REQUEST FOR INFORMATION NOT ADDRESSED IN THIS CCO REMAIN IN FORCE			
0	05/06/11	MEP INTEGRATION REV. & UPGRADES TO SYSTEMS	TW RG 163
MARK	DATE	DESCRIPTIONS	BY CH'D/CCO#
REVISIONS

CONTRACT CHANGE ORDER NO. _____
SHEET _____ OF _____

DETAILS
SKYWAY ROADWAY EASTBOUND
CONDUIT AND PULL BOX LOCATIONS
SCALE AS NOTED

E-165L

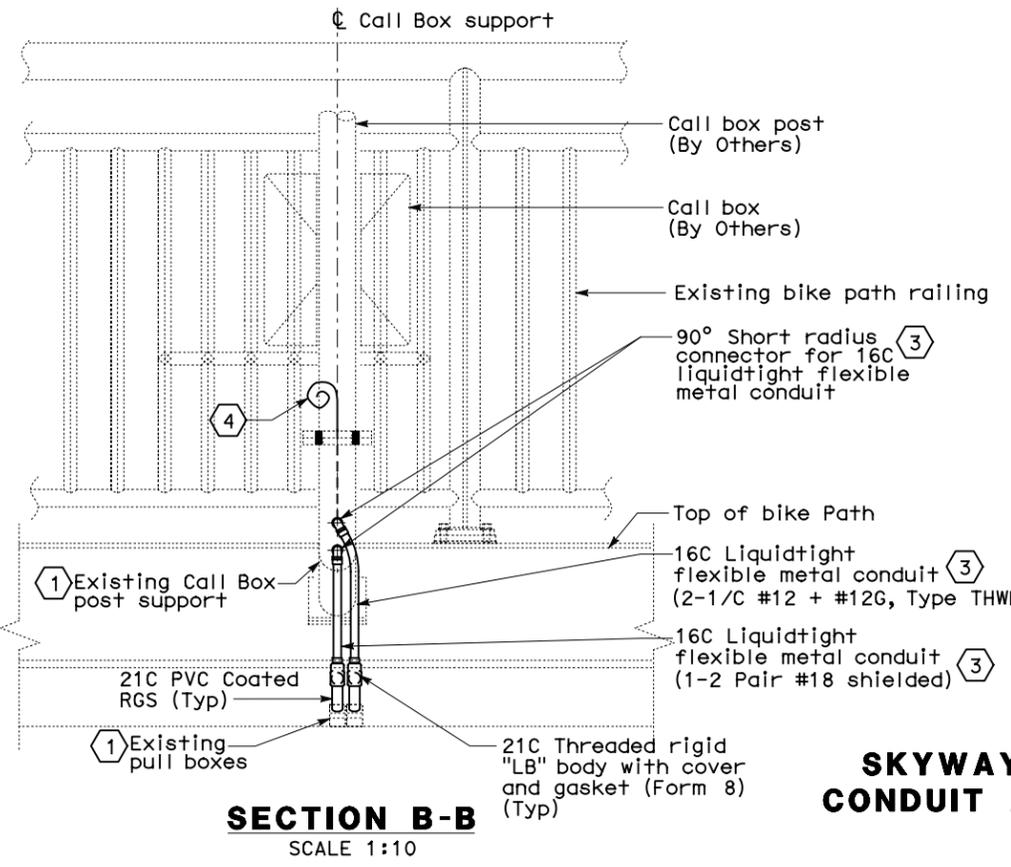
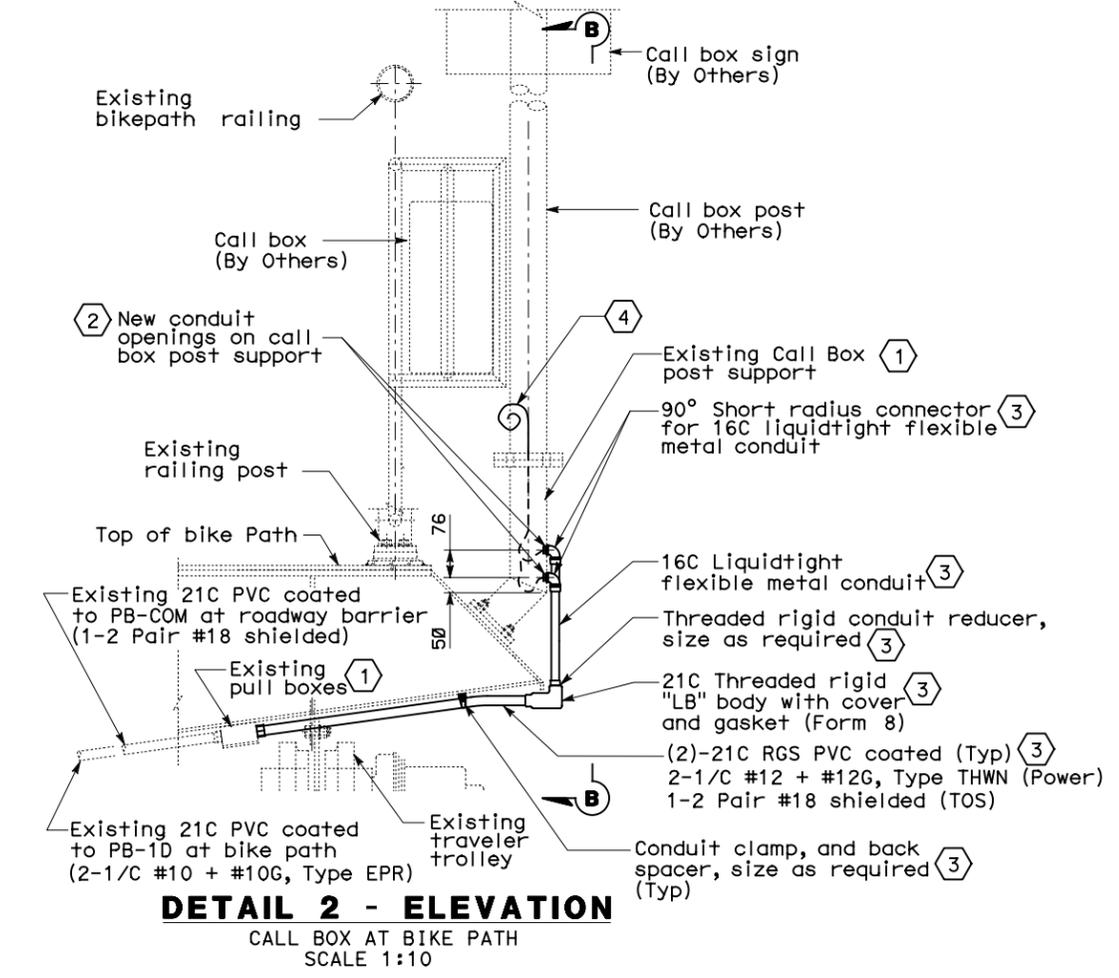
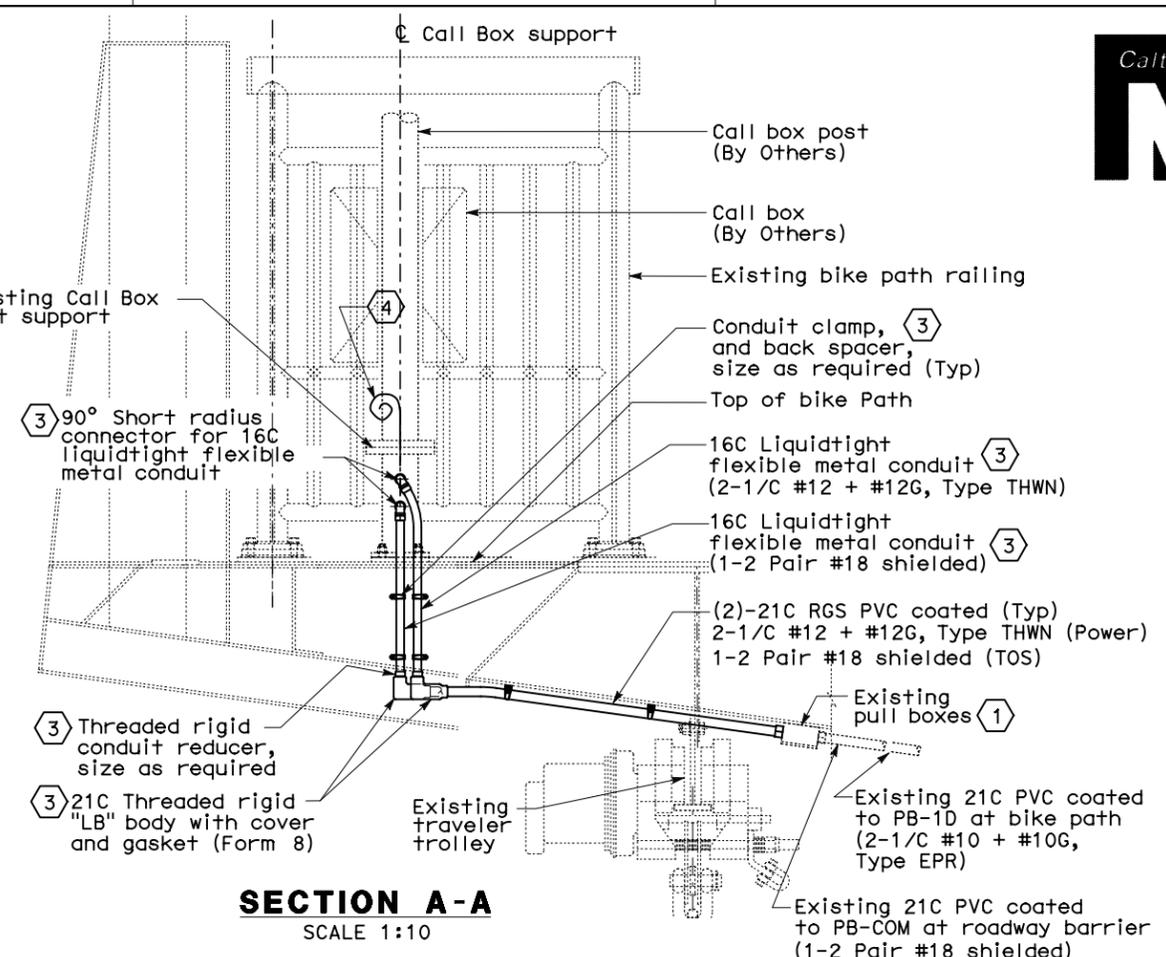
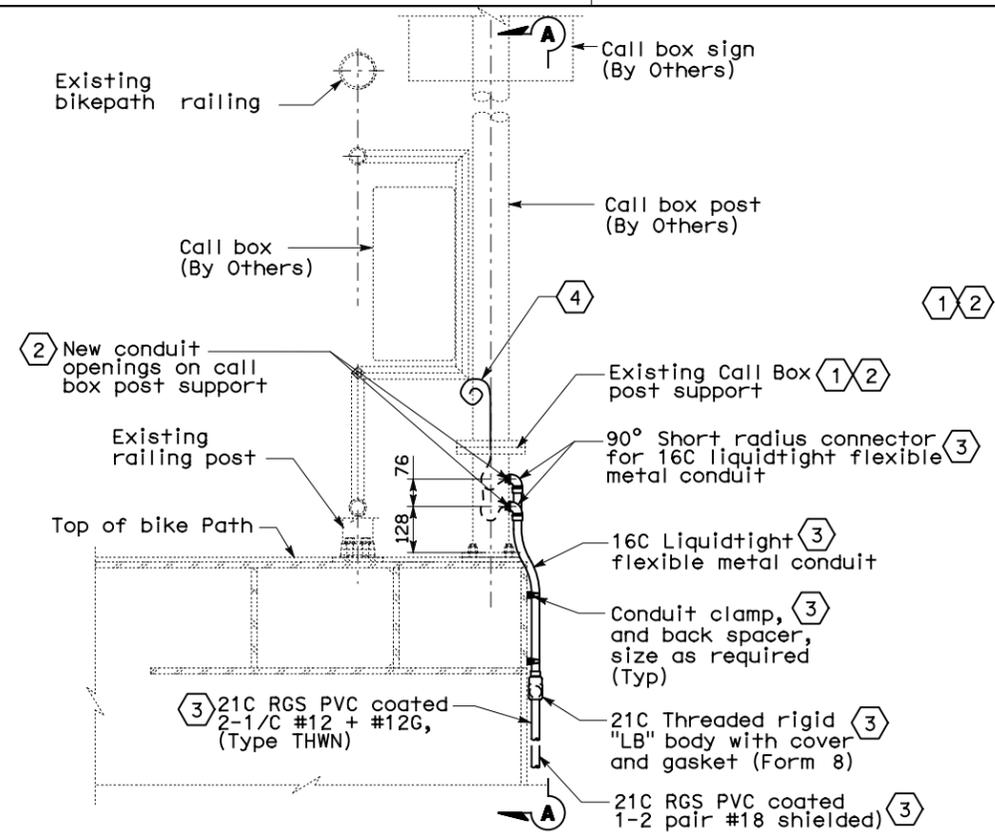
- 1 Disconnect and remove existing liquidtight flexible metal conduits intended for lighting and Comm. cables between the call box post support and the existing pull box below the bike path girder. Pull back and salvage existing conductors for future use.

- 2 Provide new threaded holes for 16C liquidtight flexible metal conduit on existing call box post support. Plug existing conduit openings using stainless steel threaded plugs.

- 3 Install new conduits and fittings between the call box post support and the respective existing pull boxes (lighting and comm.) located below the bike path girder.

- 4 Contractor shall inspect existing conductors for damage prior to repulling the conductors. Replace damaged conductors with the same type and size. Contractor shall also verify and ensure that there is sufficient length of lighting and Comm. conductor pigtails for future termination to the call box. Seal each conductor end to prevent water from entering the insulation. Pigtails shall be coiled and protected from damage. Provide weatherproof covers for the pigtails and call box supports.
